HISTORIC PRESERVATION ADVISORY BOARD CASE MEMO

TO: Historic Preservation Advisory Board
DATE: December 19, 2019
APPLICANT: Ryan Miller, *Director of Planning and Zoning*
CASE NUMBER: H2019-019; *COA for 810 N. Goliad Street*

Hold a public hearing to discuss and consider a request by Jeff Carroll of Carroll Architects, Inc. on behalf of the owner Frank Fite, II for the approval of a Certificate of Appropriateness (COA) for the construction of a new office building on a 0.4590-acre *Non-Contributing Property* identified as Lot A, Block 124, B. F. Boydston Addition, City of Rockwall, Rockwall, Texas, zoned Planned Development District 50 (PD-50), situated within the North Goliad Corridor Overlay (NGC OV) District, addressed as 810 N. Goliad Street, and take any action necessary.

The applicant -- *Jeff Carroll of Carroll Architects, Inc.* -- is requesting a Certificate of Appropriateness (COA) for the purpose of constructing a 4,987 SF office building.

SITE PLAN

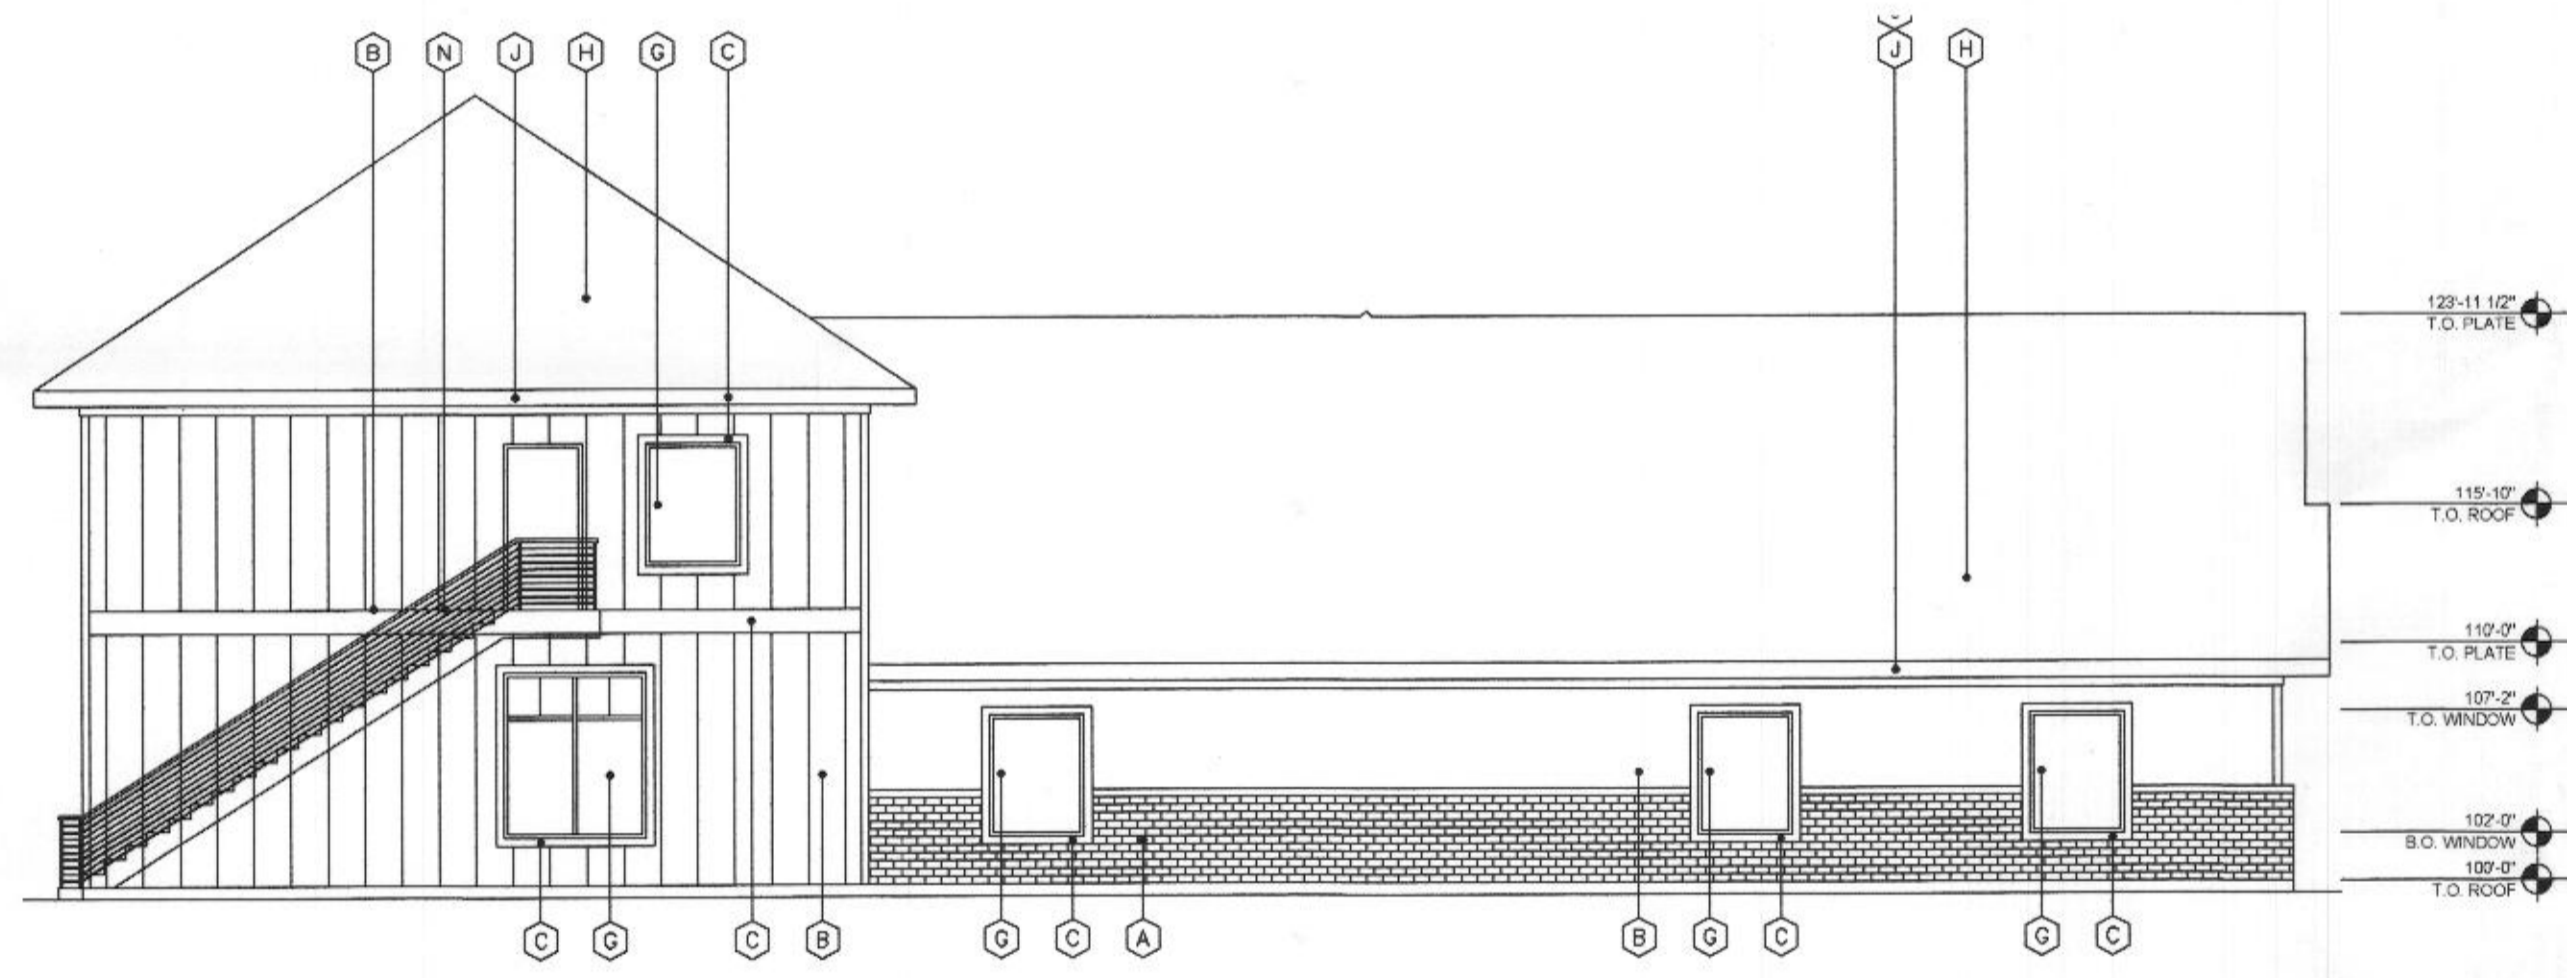
- (6) *Side Yards*. The proposed site plan does appear to conform with the majority of the guidelines’ suggestions relating to the side yard; however, staff should point out that currently a staircase appears to be in the ten (10) foot side yard setback. This encroachment would require approval by the Board of Adjustments (BOA) prior to the approval of the site plan.

- (b) Conformance to the street tree requirements stipulated by Article VIII, *Landscape and Fence Standards*, of the Unified Development Code (UDC);
- (2) The alleyway situated on 808 N. Goliad Street will need to be verified prior to the approval of a site plan. Alternatively, the applicant can secure a cross access easement on the property;

- (3) The steps situated on the north side of the subject property are located within an established building setback and either need to be moved outside of the building setback or a variance needs to be approved by the Board of Adjustments (BOA) for the encroachment;

- (5) The proposed building elevations are subject to review by the Architectural Review Board (ARB) as part of the site plan approval process;
- (6) A cross access easement (as depicted on the site plan) will need to be establish at the back of the subject property extending from the southern boundary of the subject property (*adjacent to 808 N. Goliad Street*) and extend to the northern boundary (*adjacent to 812 N. Goliad Street*); and,

EXTERIOR ELEVATIONS

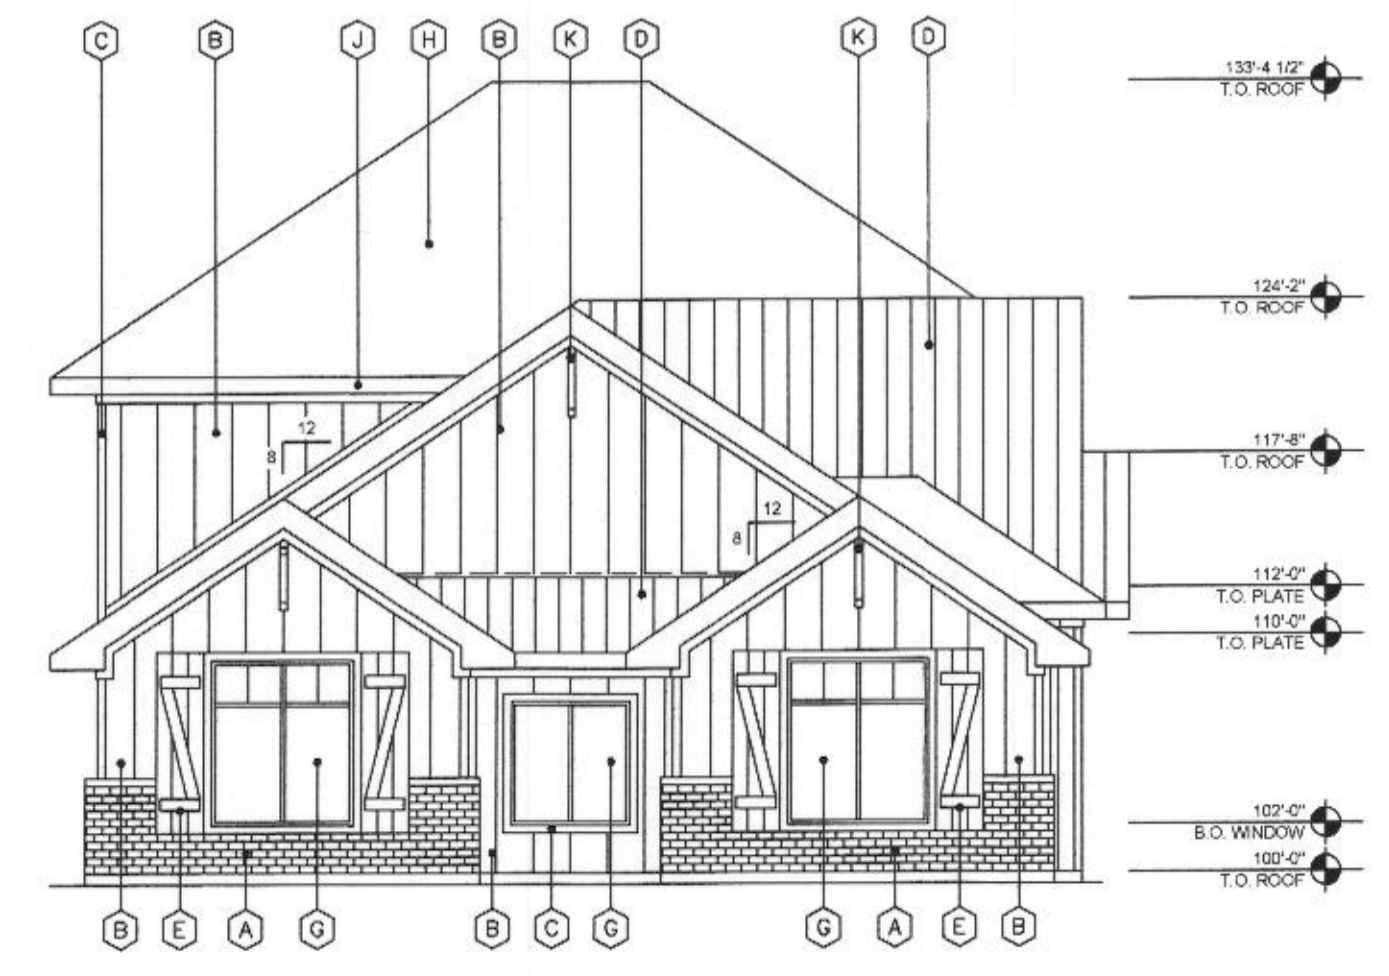
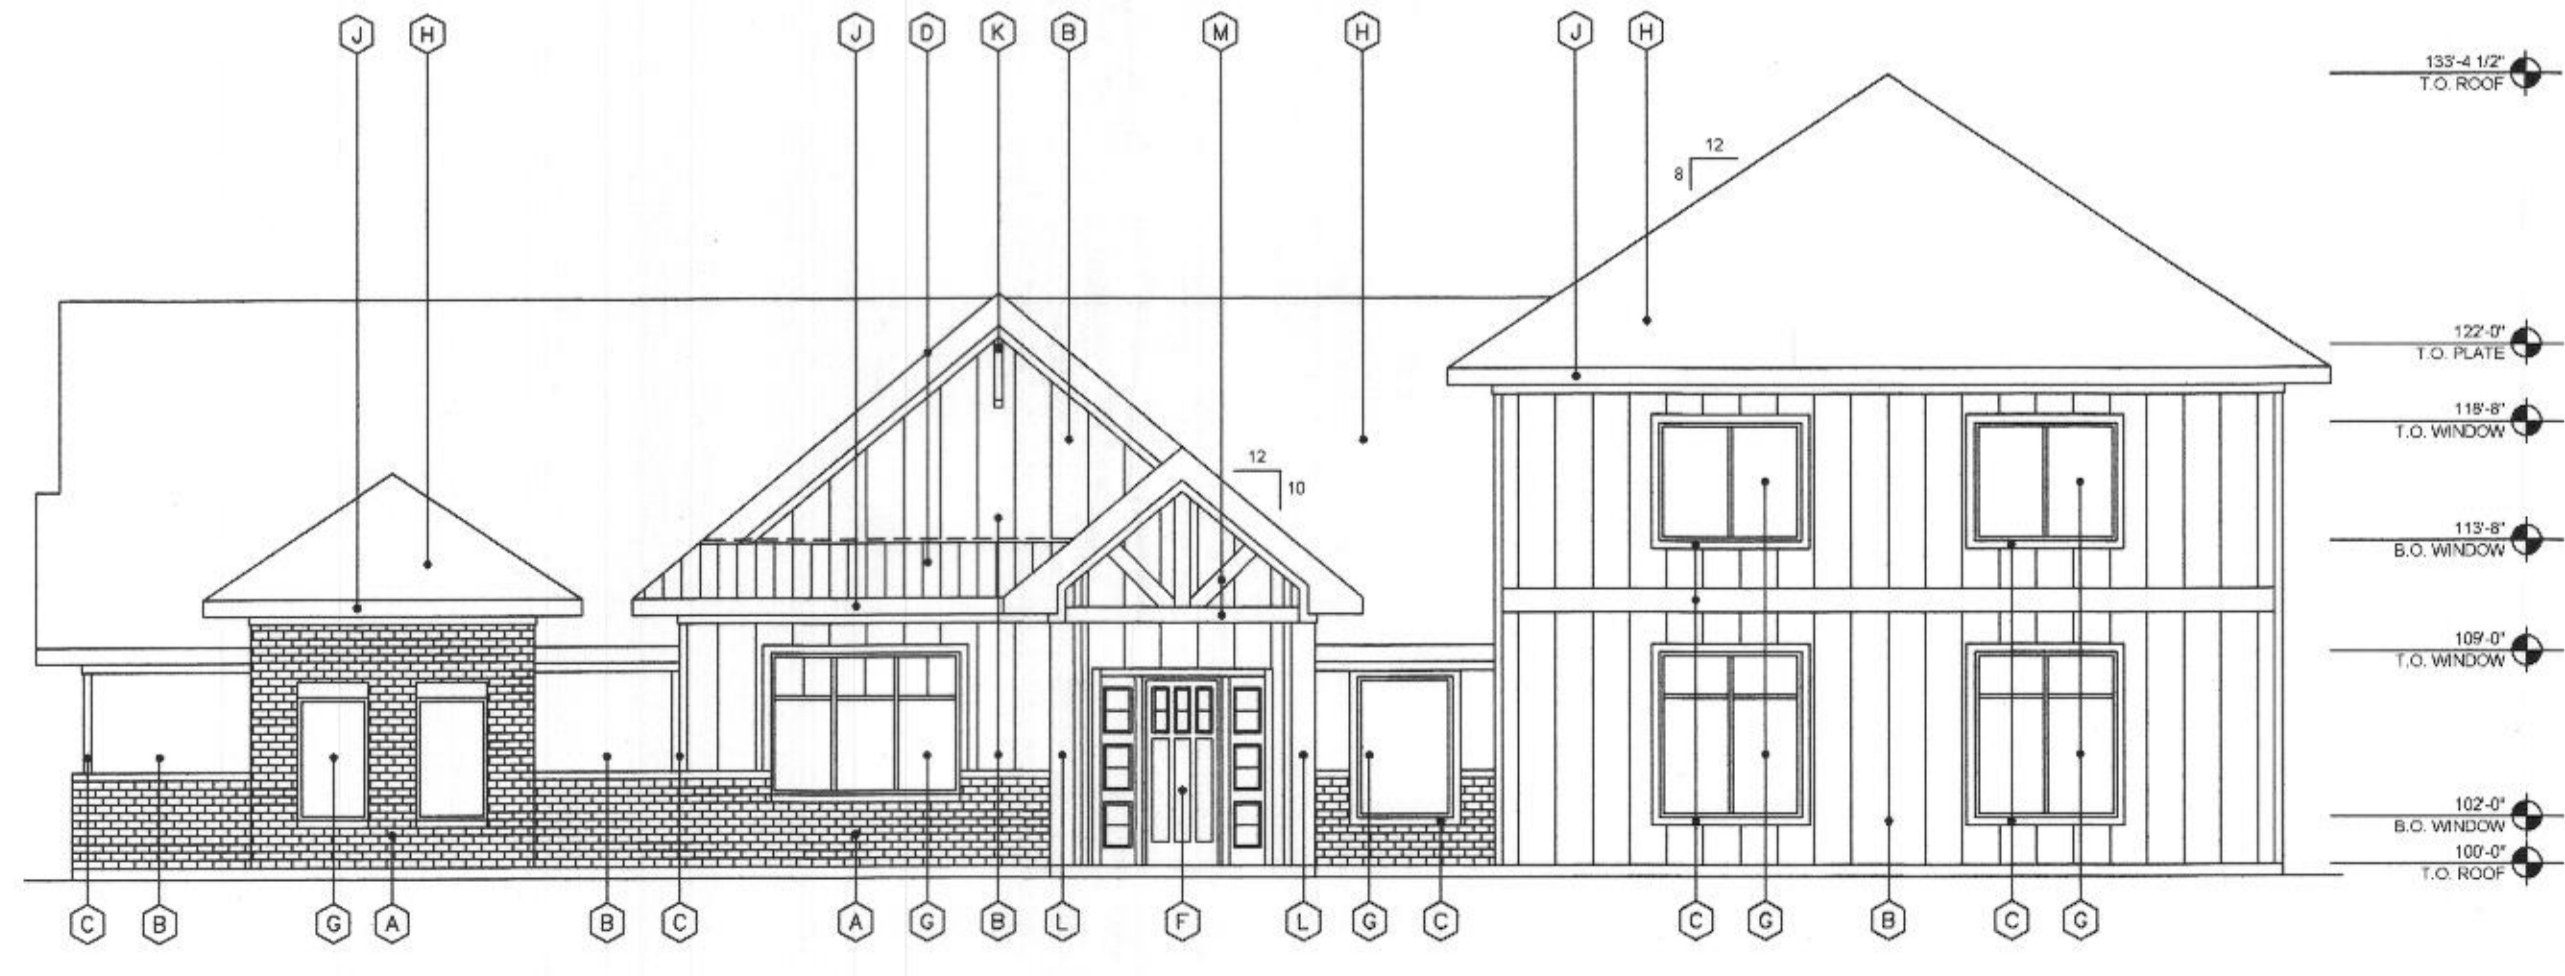
- (1) *Height*. The guidelines stipulate that new buildings be constructed to a similar residential scale as adjacent properties. In this case, the building is 33-feet in height, which is in conformance with the 36-foot height limitation for the Residential-Office (RO) District.
- (2) *Building Setback and Orientation*. The guidelines refer to new buildings being built utilizing similar setbacks and orientations as existing buildings. In addition, the guidelines state that new structures should be constructed so that new buildings maintain the *pier-and-beam* appearance. The proposed structure does maintain a *pier-and-beam* appearance by incorporating a brick wainscot along the bottom; however, the building is oriented to the side yard. Staff has

recommended to the applicant that a front entry, stoop, and deck be incorporated in the design on the front of the building to create a product that appears to be oriented toward the front of the property (*i.e. fronting the building onto S. Goliad Street*). Staff should note that no other property in Planned Development District 50 (PD-50) is oriented to the side yard like what is being proposed by the applicant.

- (5) *Front Yards*. As was stated previously, staff has recommended to the applicant changing the western building elevation to incorporate an entryway giving the appearance that the property fronts to S. Goliad Street. In addition, the applicant will be required to provide a detailed landscape plan with the site plan for the front yard areas.

LANDSCAPE PLAN

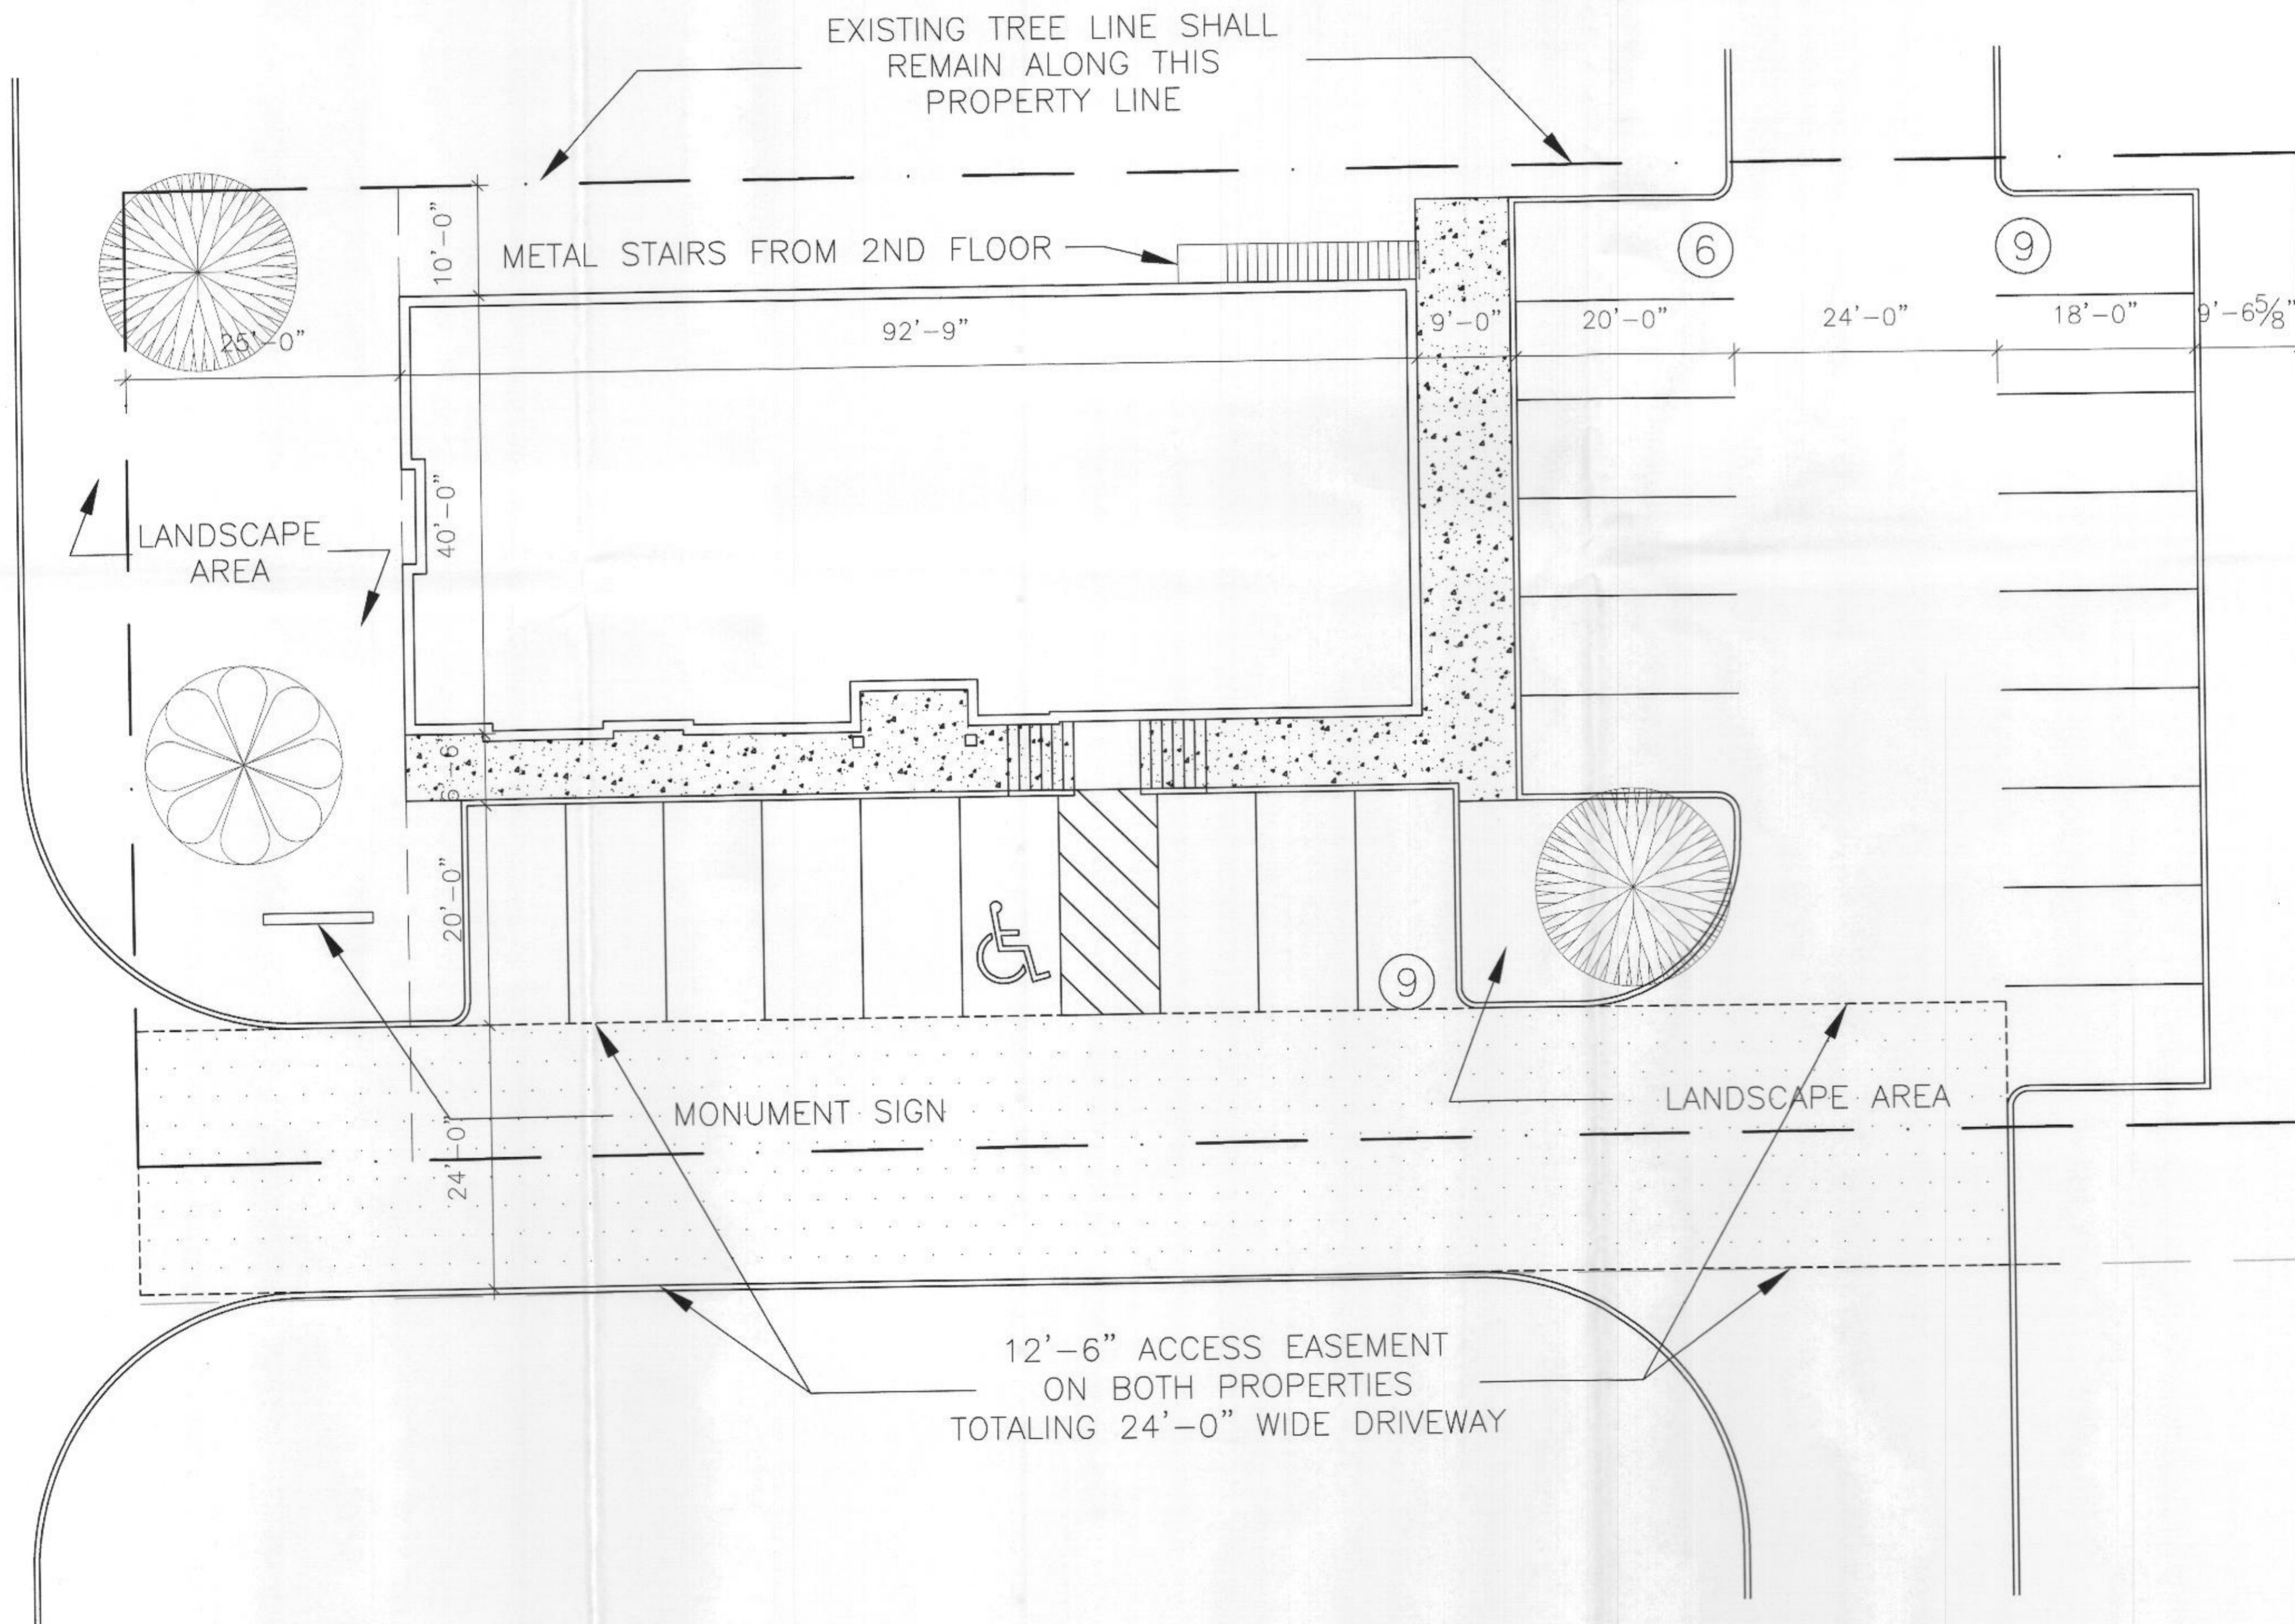
- (1) *Residential Adjacency*. Subsection 5.02(B), *Screening from Residential*, of Article VIII, *Landscape and Screening Standards*, of the Unified Development Code (UDC) requires either [1] a minimum six (6) masonry fence with canopy trees on 20-foot centers or [2] three (3) tiered screening with a minimum six (6) wrought iron fence be established adjacent to, “(a)ny non-residential or multi-family land use or parking area that has a side or rear contiguous to any residentially zoned or used property...” In this case, the property directly east of the subject property is zoned Single Family 7

- (2) *Landscape Plan*. A more detailed landscape and treescape plan will be required to be submitted to ensure compliance to the tree planting requirements, which require a minimum of one (1) canopy tree and one (1) accent tree be planted adjacent to N. Goliad Street per 100 linear feet of frontage.

- (1) A more detailed Landscape and Treescape Plan shall be submitted with the site plan showing conformance with the following:
 - (a) Landscaping and/or a berm -- *generally in conformance with the Historic Guidelines* -- should be incorporated in between N. Goliad Street and the parking lot to screen the parking areas;
